# Final Environmental Impact Statement for the Arturo Mine Project

Bureau of Land Management

January 2014

Elko District Office, Tuscarora Field Office, Nevada

Figure 3.4-1

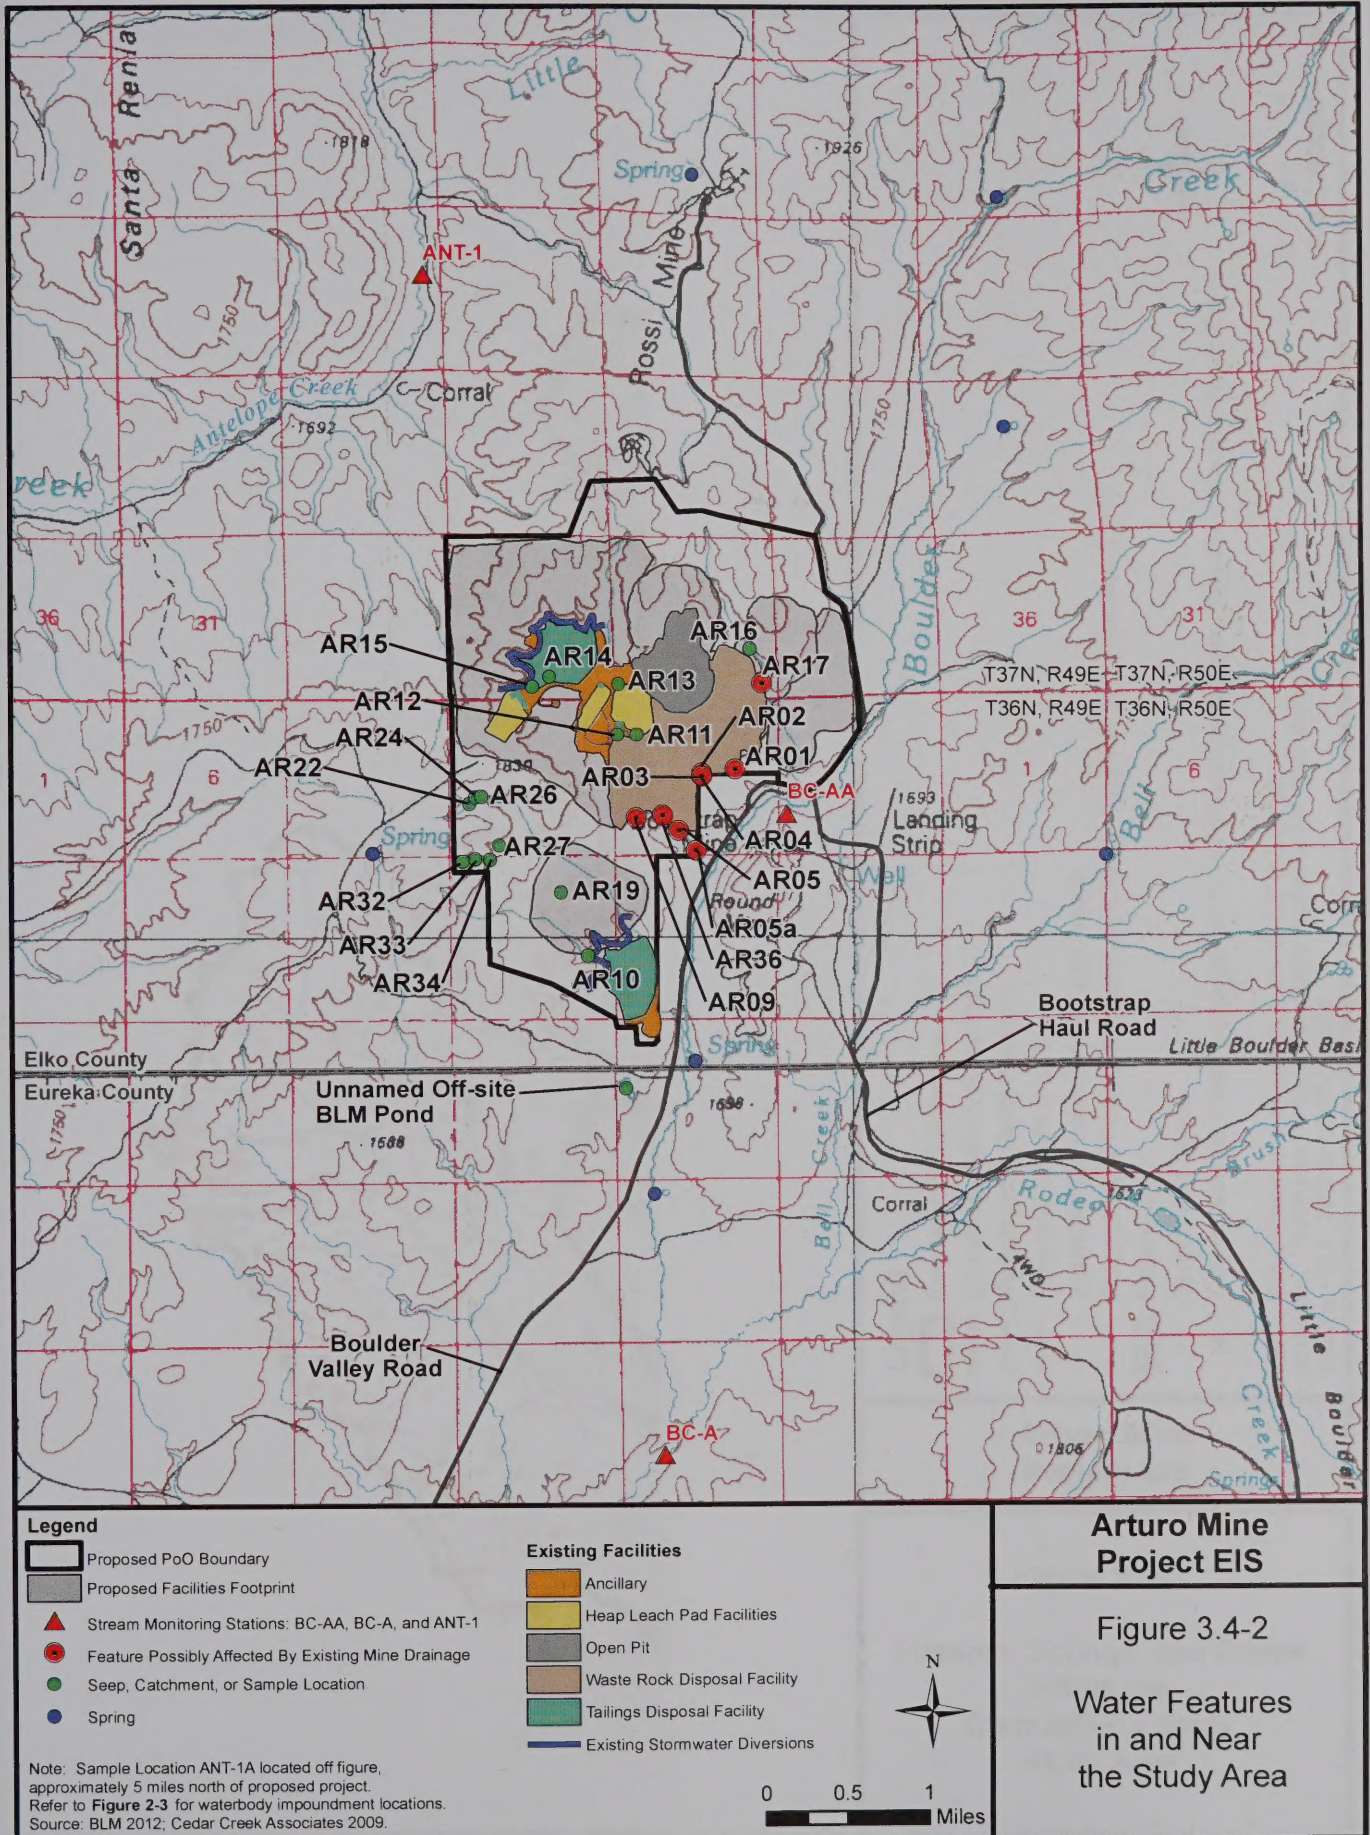
The DEIS did not include a map identifying the hydrologic study area for direct and indirect impacts to water resources as described on page 3.4-1. The textual description is insufficient and the visual cues provided in reference to figure 3.4-2 only provide north/south bounds for the study area, and do not indicate the overall area considered. The DEIS does not address whether potential impacts to Antelope Creek were included in the direct/indirect study area or whether impacts to Antelope Creek were only examined in the cumulative context.

F2-34 Figure 3.4-1 has been revised to show the indirect/direct study area and the CESA. Monitoring stations associated with the study area and Antelope Creek have been added to Figures 3.4-2, 3.4-5, and 3.4-6 in response to this comment. The description of the study area on page 3.4-1 has been revised to include the Rock Creek Valley/Antelope Creek study area.
